MANDATORY SERVICE BULLETIN

MSB 42MNG-006

Type: DA 42 M-NG

Installation of an additional wire for the alternator fail relay.

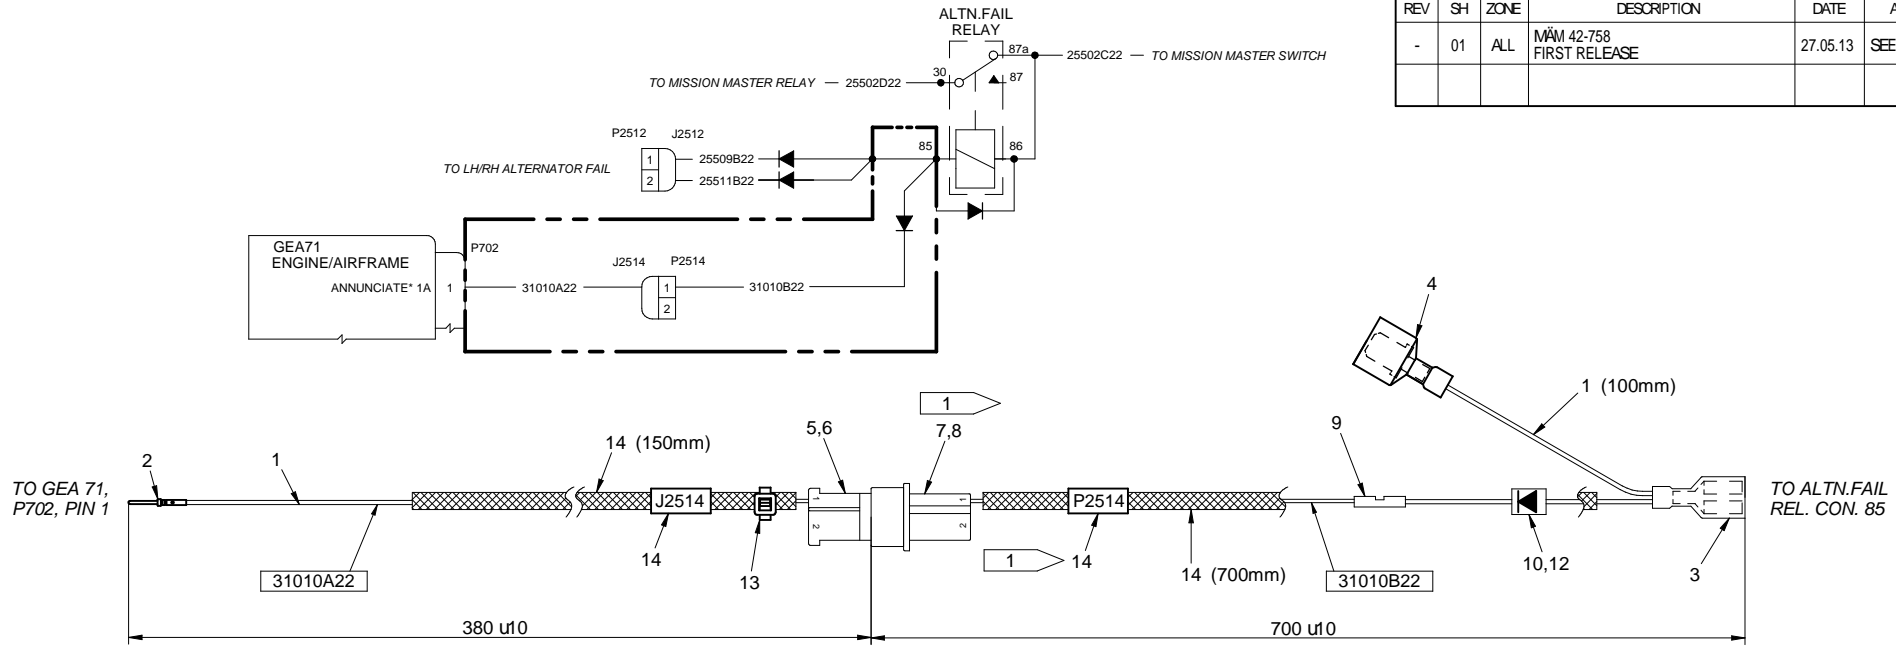
8	<p>If the airplane is <u>not</u> equipped with an oxygen system, replace one hole plug with the grommet P/N 5616632.</p> <p>If the airplane is equipped with an oxygen system, drill a hole diameter 8,5 mm adjacent to the existing holes (see Figure 1) and protect edges with the grommet P/N 5616632.</p> <div data-bbox="384 508 1326 1111" data-label="Image">A photograph showing the interior of an aircraft's instrument panel area. A large, black, braided flexible conduit is routed across the panel. Below it, a busbar assembly is visible with a yellow label that reads 'BUSS' and '100A'. To the right, a blue grommet is already installed in a hole. A red dot and arrow point to a location on the panel surface adjacent to the existing holes, indicating where a new hole should be drilled.</div>
9	Route wire 31010B22 of D62-2510-97-00-SB through the grommet into the instrument panel.
10	Install the label P2514 onto the wire and insert the pin of wire 31010B22 into the connector position 1. Refer also to drawing D62-2510-97-00-SB.
